## Planning Commission Staff Report

**Meeting Date:** May 9, 2022

**Description:** **Stoneridge Office Building Sign Package:** A Sign Package for a 9.27-acre tract of land zoned “PC” Planned Commercial District located along South Outer Forty, east of its intersection with Yarmouth Point Dr. (19R610400).

Figure 5: Proposed Incidental Sign

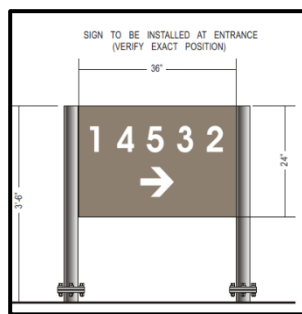
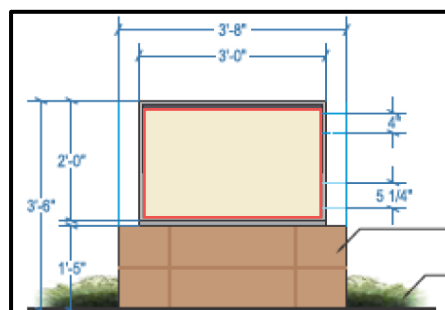
No changes are proposed for the existing monument sign. The applicant is proposing a new design for the incidental sign at the entrance that was conditioned by City Council. The proposed address sign will still maintain a height of 3'6" and width of 3'8". It will have a closed base with landscaping in nearly the same location where the sign exists today. Figures 5 and 6 below illustrate the changes proposed.

Figure 7: Proposed North Elevation Signage Criteria

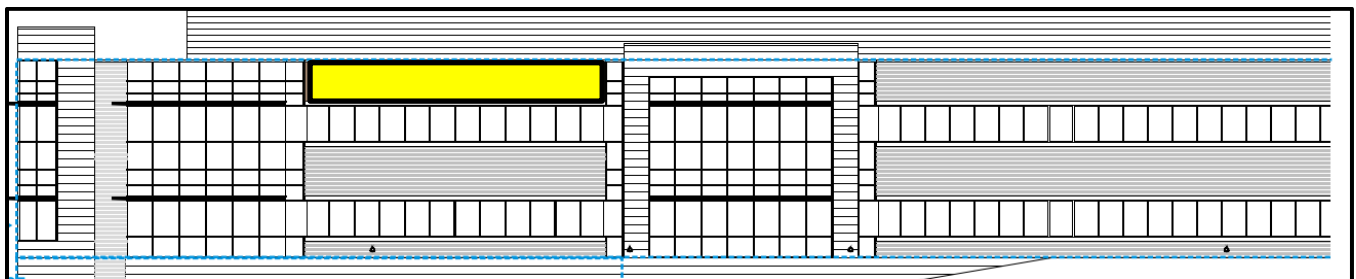
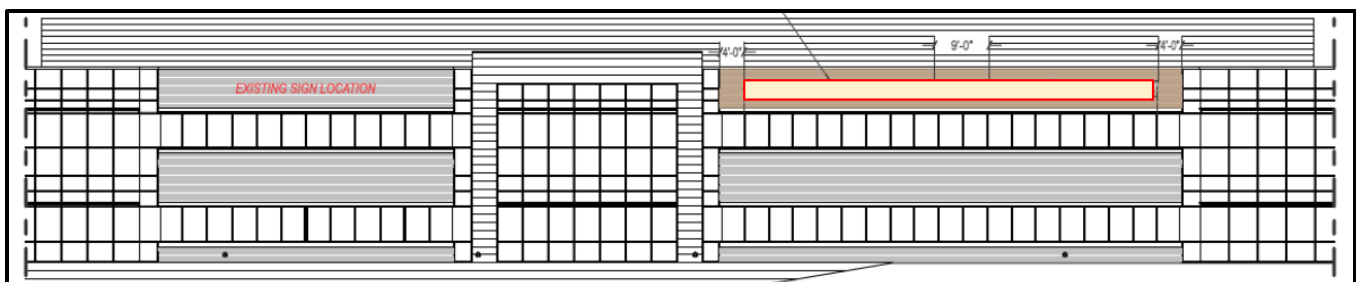
The applicant is requesting a slightly smaller size allowance on the east elevation from 226.65 sq. ft. to 225.4 sq. ft. for this sign (approximately 1.25 sq. ft. less). For the north elevation, one (1) wall sign on the top *right* corner, totaling 216.4 ft<sup>2</sup> in area is proposed. Though the proposed sign area is less than the current sign package, the specific location and dimensions of the north elevation wall signage are detailed in the current sign package, thus an amended sign package is warranted to change these criteria. The difference between the current and proposed sign criteria for the north elevation is illustrated in Figures 6 and 7, and Table 2.:

<b>Criteria</b>	<b>Existing</b>	<b>Proposed</b>
Location	Top Left of N. Elevation	Top Right of N. Elevation
Height	5'6"	3'2"
Width	46'8"	68'4"
